CONSTRUCTION PLANS  
FOR  
**SKYLINE AT LORSON RANCH FILING NO. 1**  
STREET AND STORM SEWER  
CONSTRUCTION PLANS

SF-22-001

# ENG-SF22001-R2-CDs.pdf Markup Summary

FOREBAY SECTION A-A  
NO SCALE

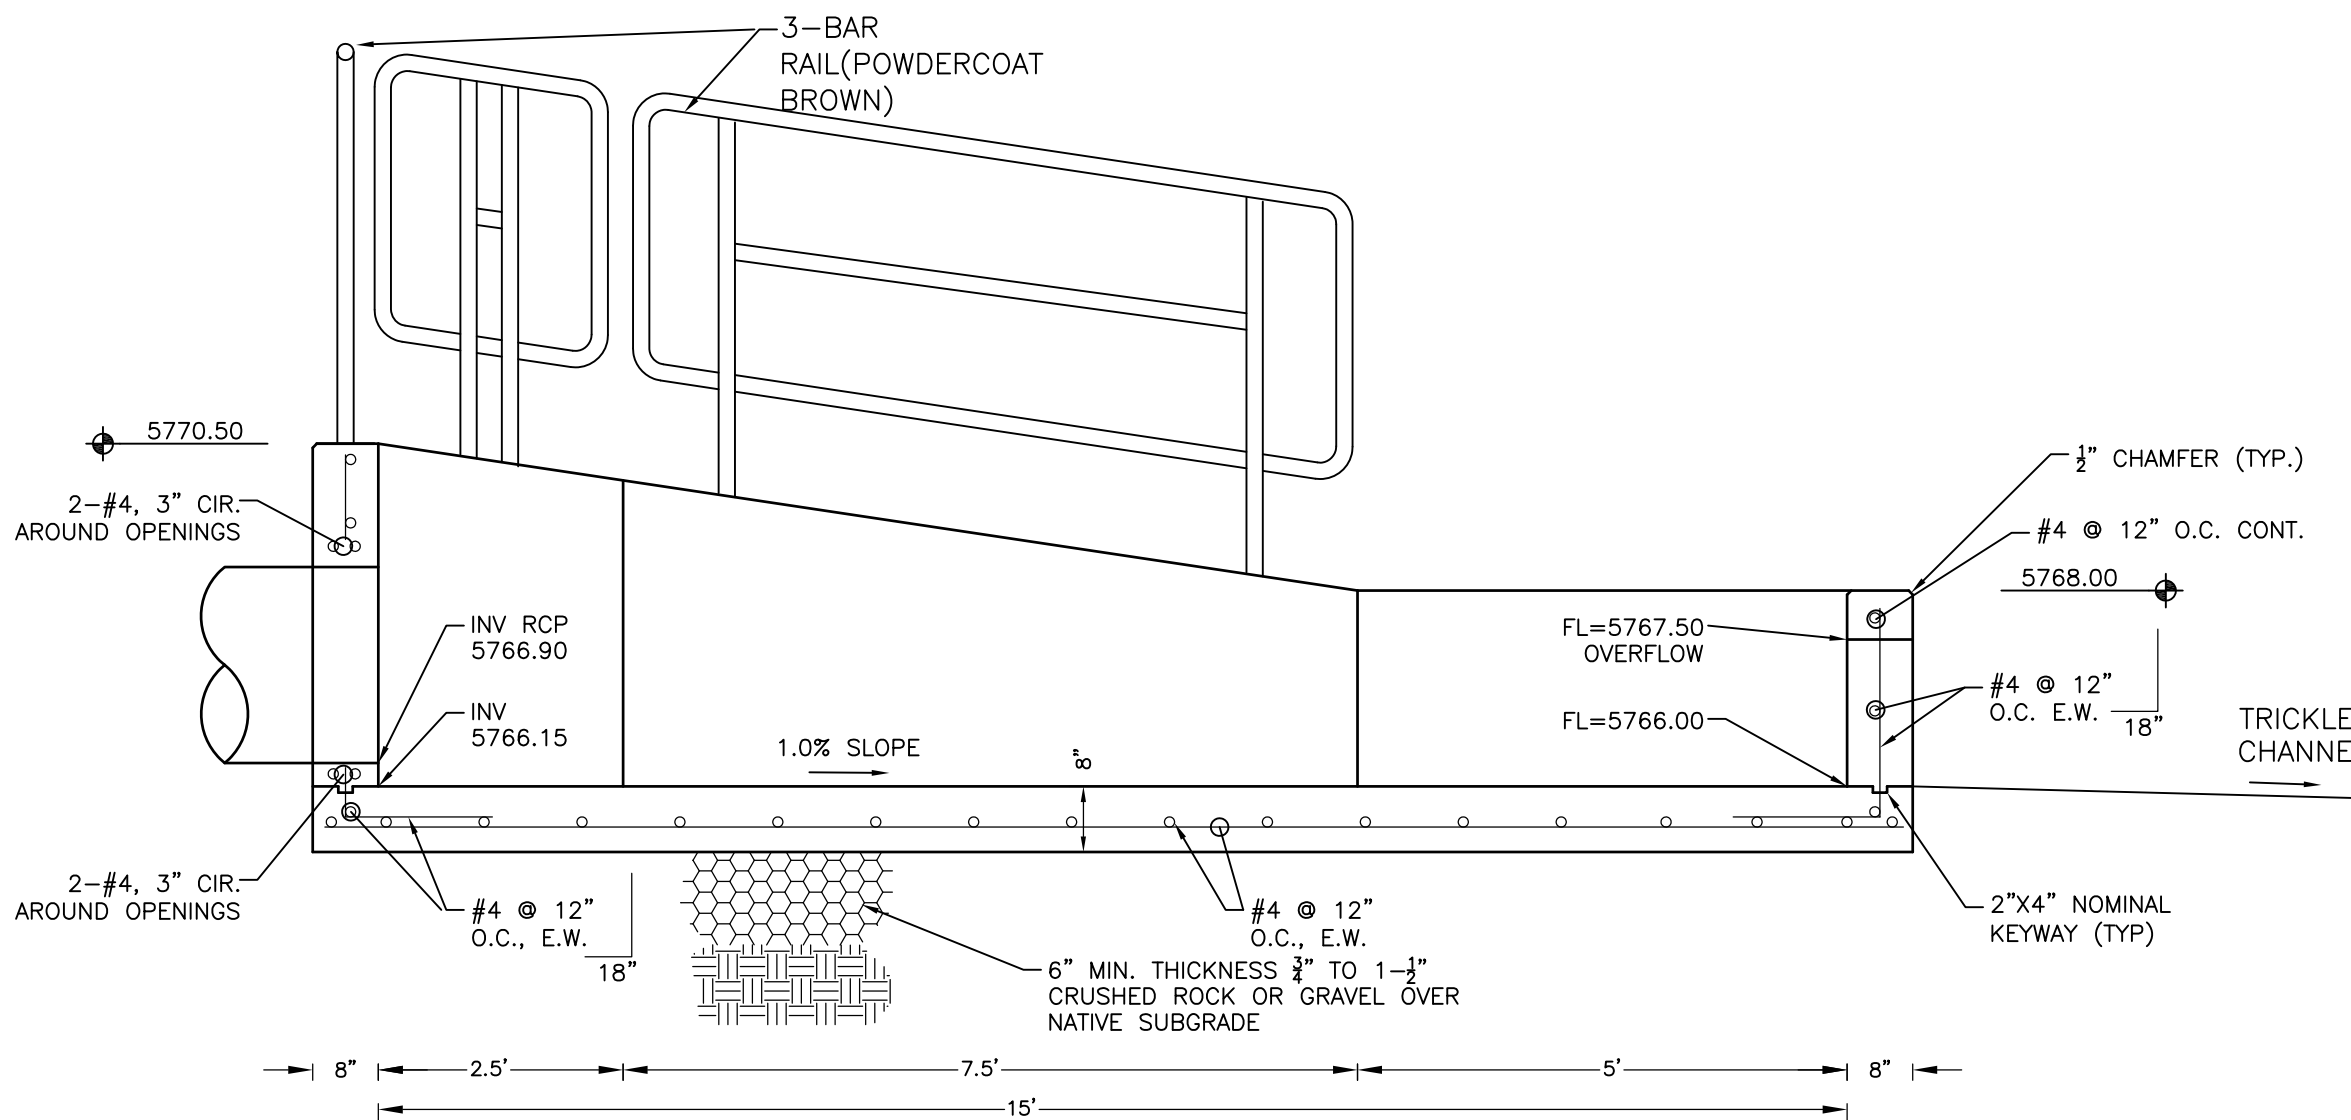
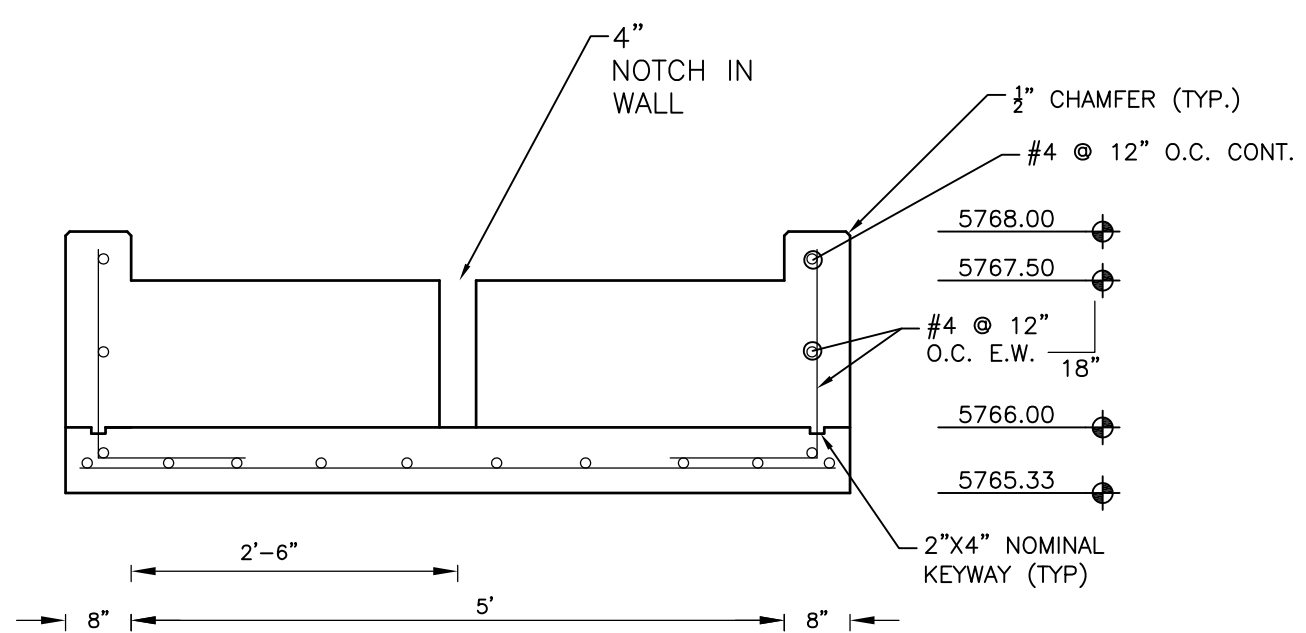
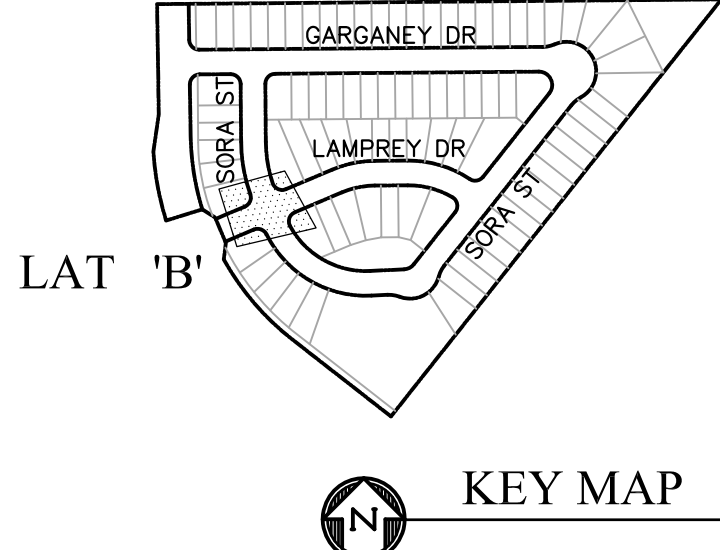
Unresolved comment from Review #1:  
Per MHFD USDCMv2 Chap 9, Section 3.2.4 (pdf  
pages 89 to 99), forebay baffles are required for  
inlet pipes up to 48" diameter.
